10 November 2021

Section 4.55(1A) Modification to SSDA 9036 – Concord Hospital Redevelopment – MOD 7

Figure 2 Total number of parking spaces remaining at the Hospital Road on-grade car park after the new MSCP is developed
Source: Arup

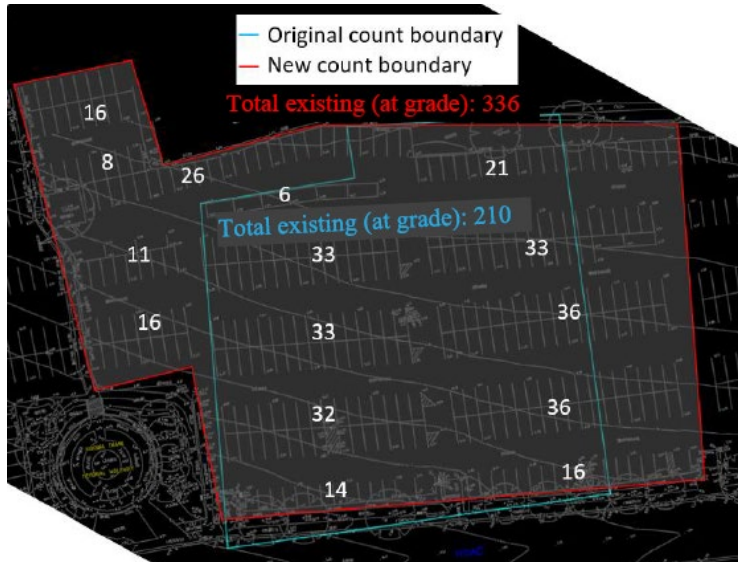
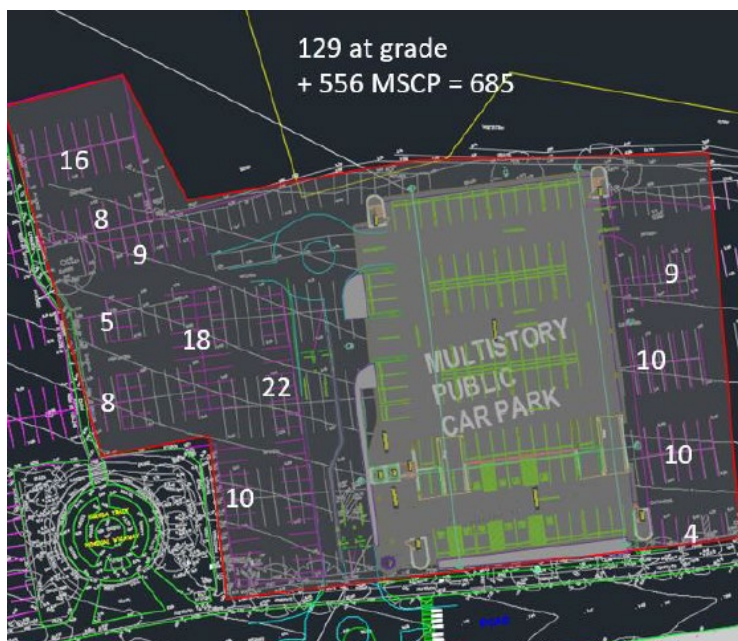
The proposed amendment to the wording of Condition of Consent D28 is required to ensure that the 2,381 campus parking demand for Stage 1 of the Concord Hospital Redevelopment can be met. To meet the Stage 1 demand of 2,381 parking spaces, the intention of the new MSCP is to build it over the existing Hospital Road on-grade car park; as such, this displaces some of the existing on-grade parking spaces to deliver more spaces in a multi-storey structure, in accordance with **Figure 1** and **Figure 2** below.

Additionally, the provision of the new MSCP footprint and associated access road would result in permanent changes to the existing adjacent car park (shown in purple at **Figure 2**). From the on-grade car parking adjustments alone (without consideration of the new MSCP), there will be the removal of 207 on-grade spaces to accommodate the new MSCP and associated access road. A minimum of 550 new car parking spaces (or total of 556 spaces according to current design) will be provided within the MSCP footprint.

Figure 3 Landscape plan for on-grade car park showing tree removal
Source: Site Image

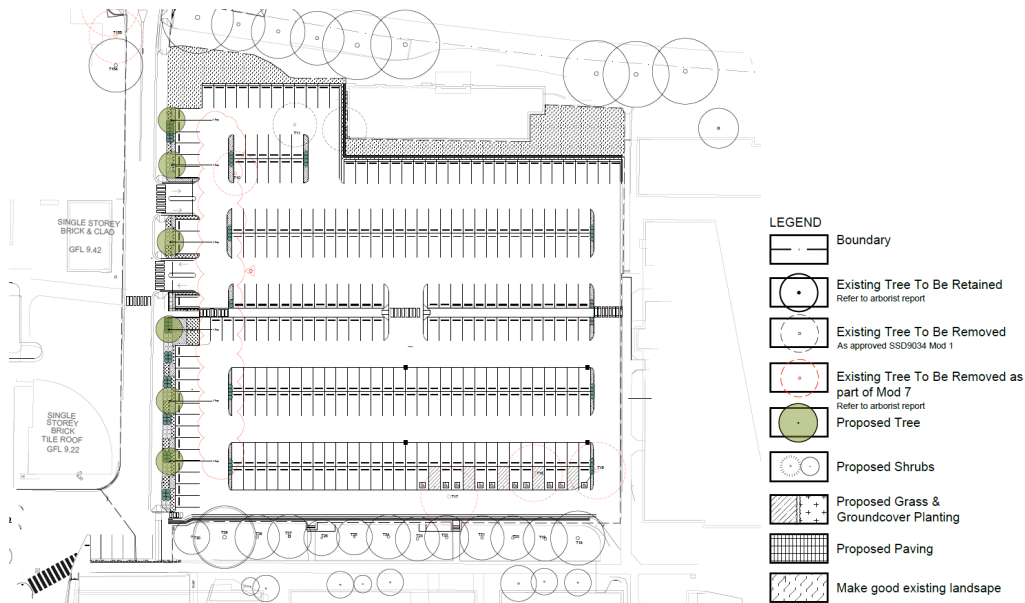
A total of thirty-eight (38) trees were assessed for the works, with ten (10) additional trees requiring removal as part of Mod 7. Of these, seven (7) are deemed as low and medium retention value and three (3) trees are deemed as high retention value. The removal of trees is required as they directly conflict with the footprint of the MSCP and on-grade car park, the footprint of the widened road entrance to the on-grade car park, and the cut required for the MSCP crossover.

Refer to **Table 5** for a summary of additional tree removal, and to **Figure 3** and **Figure 4** for proposed landscape plans.

Tree no.'s 150 and 164 are part of the street tree planting which extend the predominant length of the Hospital site and along the verge on the western side of Hospital Road. These trees are proposed for removal as they are within the footprint of the cut required for the MSCP crossover.
